U. S. NUCLEAR REGULATORY COMMISSION
REGION V

Report No. 50-312/86-09

Facility Name: Rancho Seco Unit 1

Meeting in Region V offices on February 10, 1986 (Report 50-312/86-09)

ADV MANUAL CONTROL

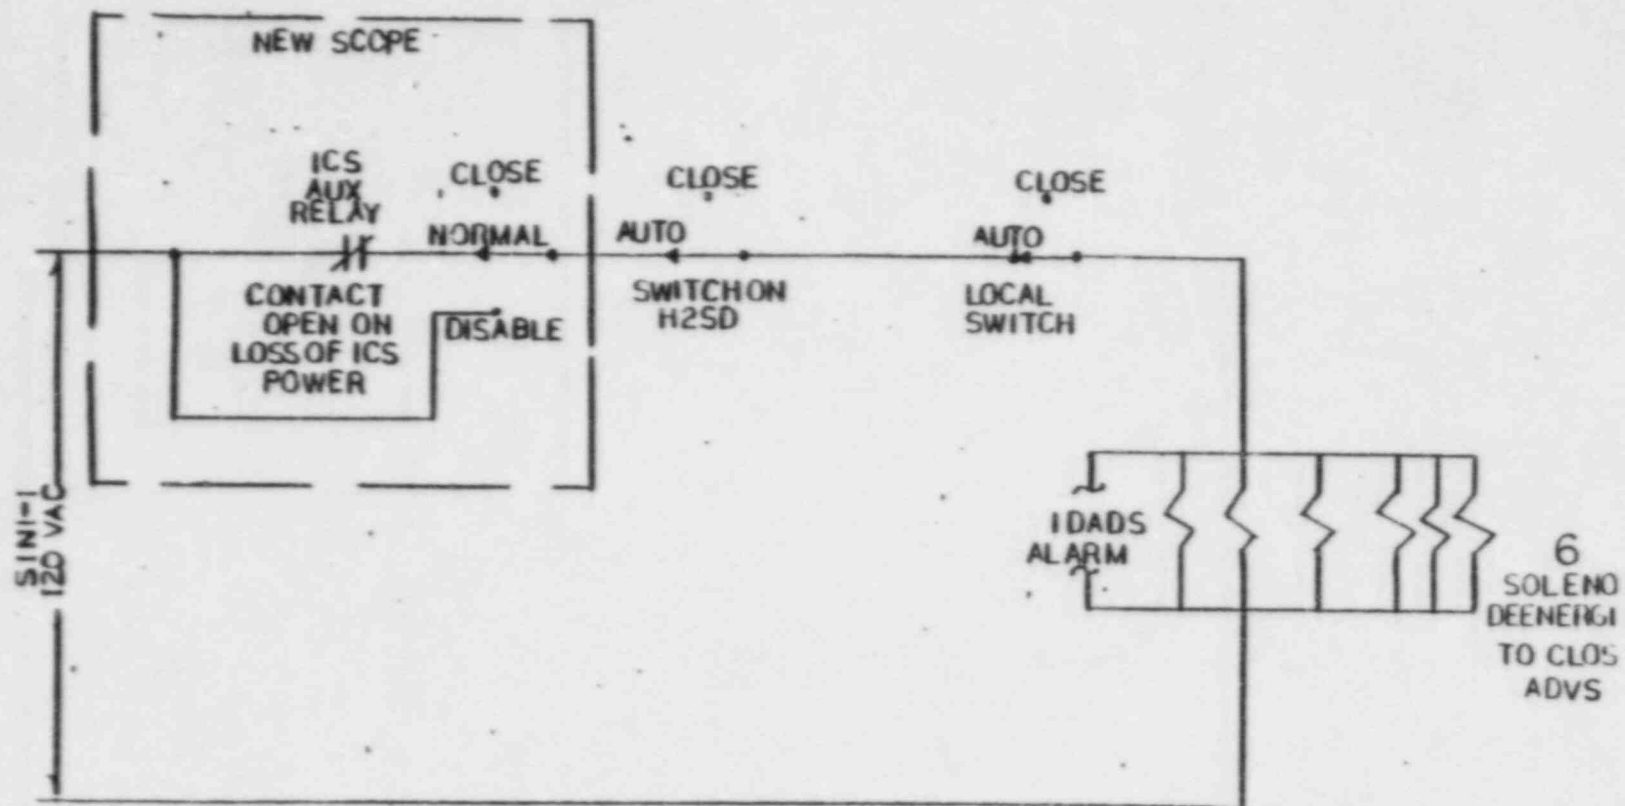
- ° ICS CABINETS AND POWER SUPPLIES
- ° ICS/AFW FLOW CONTROL VALVE INTERFACE
- ° ICS/ADV INTERFACE
- ° ICS/TBV INTERFACE
- ° TECHNICAL SUPPORT CENTER (TSC) SPRINKLER SYSTEM
- ° MAIN STEAM LINE FAILURE LOGIC SETPOINT CHANGE

- ° IMPLEMENTING MODIFICATIONS TO REDUCE LIKELYHOOD OF LOICS POWER
- ° IMPLEMENTING MODIFICATIONS TO ENHANCE THE EFFECTIVENESS OF THE OPERATOR FROM THE CR
- ° CR CONTROL INDEPENDENT OF ICS FOR:
 - AFW FLOW VALVES
 - ADV's
 - TBV's
- ° SIMILAR TO OTHER B & W PLANTS

FIGURE 2

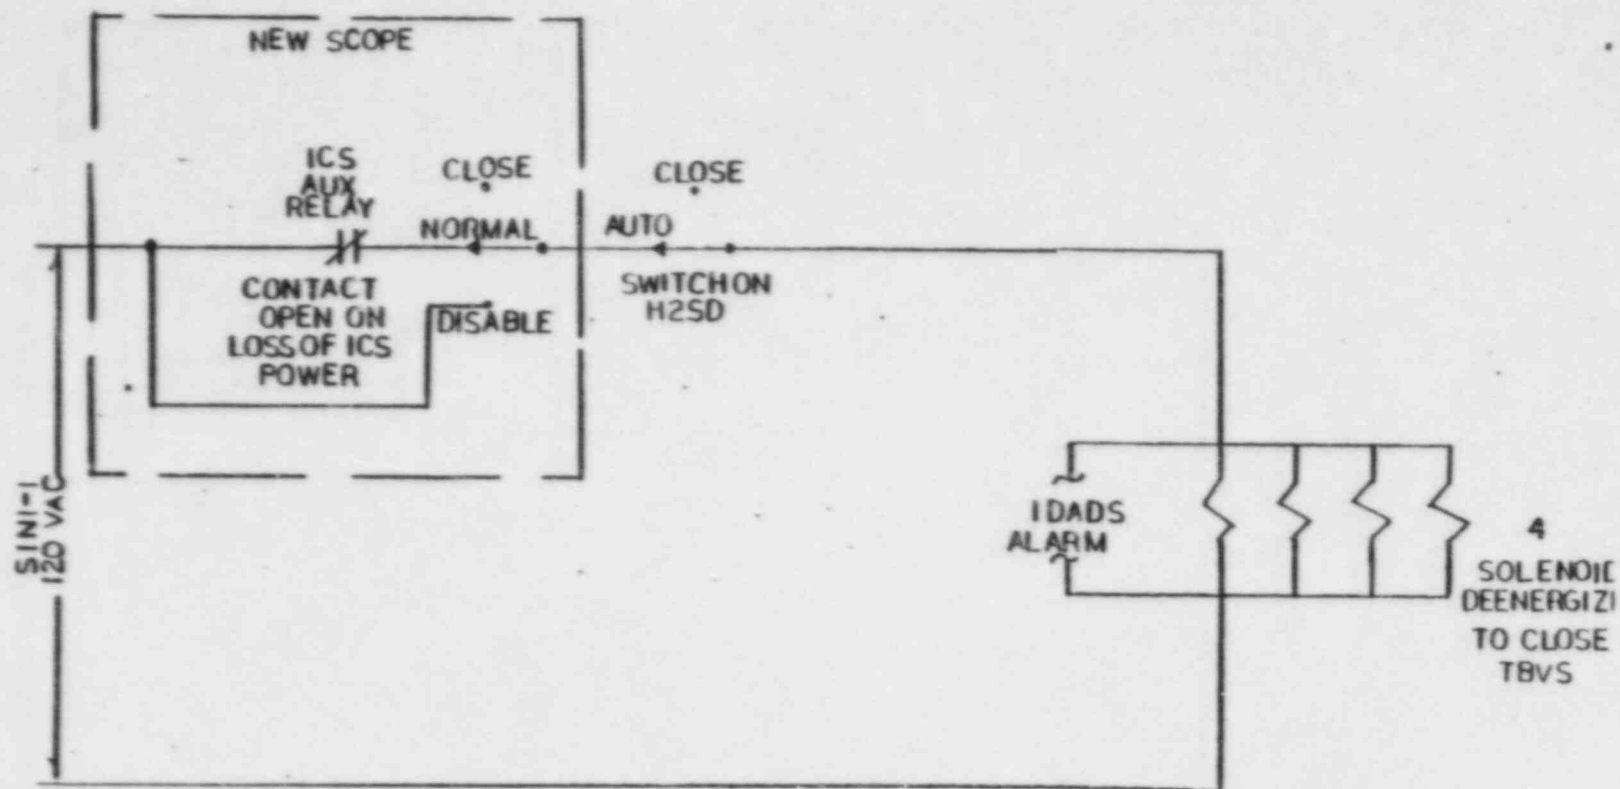
TBV MANUAL CONTROL

Figure 3.1.2-2

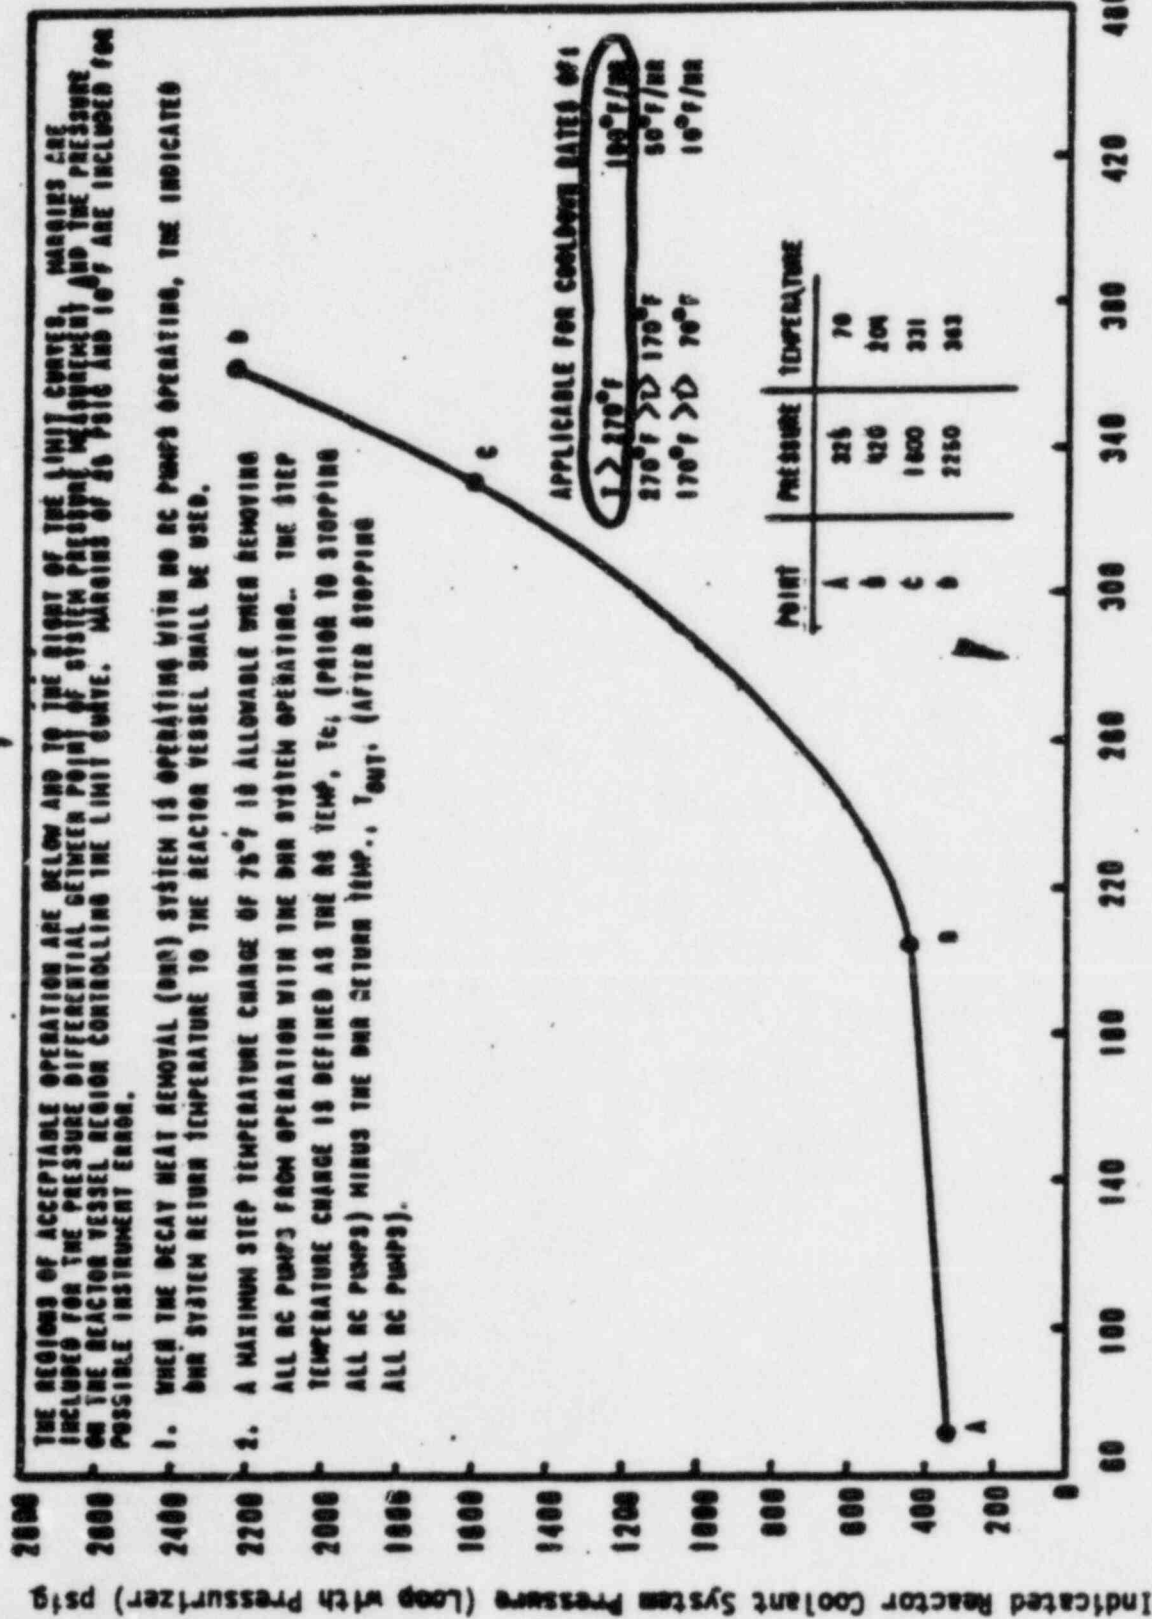
LINEAR COOLDOWN USED IN ANALYSIS

- THERMAL GRADIENT IS REAL LIMIT
- MANY WAYS TO COOL DOWN
- PRESENT INTERPRETATION

NEW P/T CURVE GENERATED

- STEP CHANGES ALLOWED
- TEMPERATURE SPECIFIED ABOVE WHICH
ANY TRANSIENT ALLOWED
- TECHNICAL SPECIFICATION CHANGE WILL
BE REQUESTED
